DAVIS
SQUARE
ARCHITECTS

August 25, 2020

RE: 500 Harvard Street
Architectural Preliminary Peer Review Report

View of streetscape where proposed building would be "contextual."

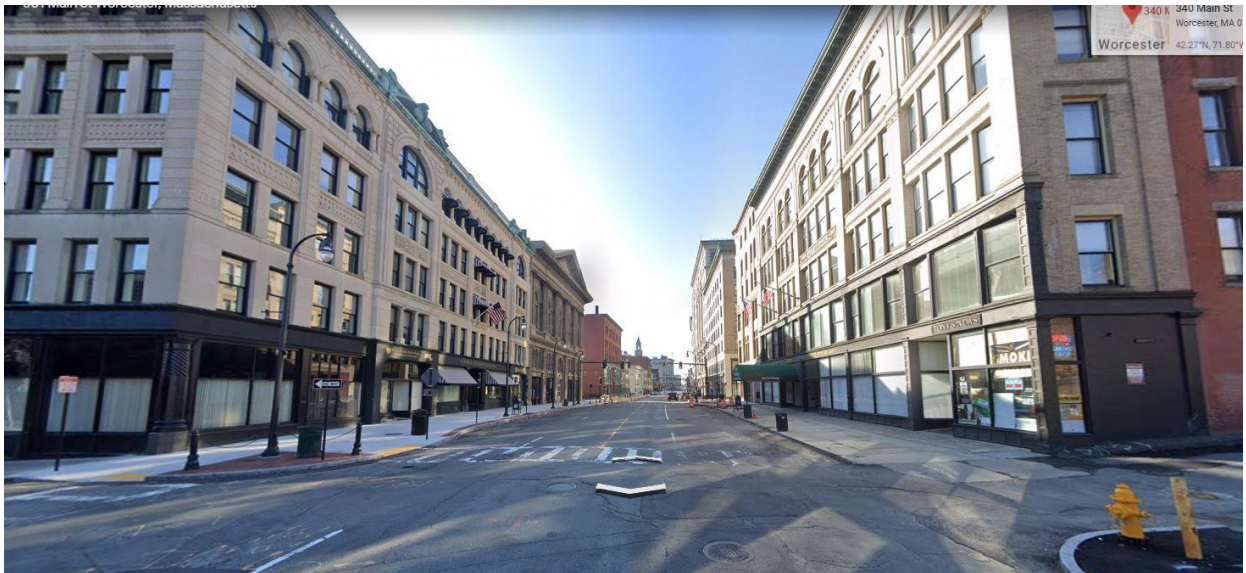
The type of streetscape resulting from this approach can work in some well-established, successful urban environments (see attached image from Main Street, Worcester). But at this location in Brookline (and nearby Boston), the proposed building does not "creates a dialogue with the existing architectural context in Brookline", nor does it "create a modern expression that is not foreign to its surroundings" (quotes are excerpted from the Architectural Project Narrative included in the submitted materials).
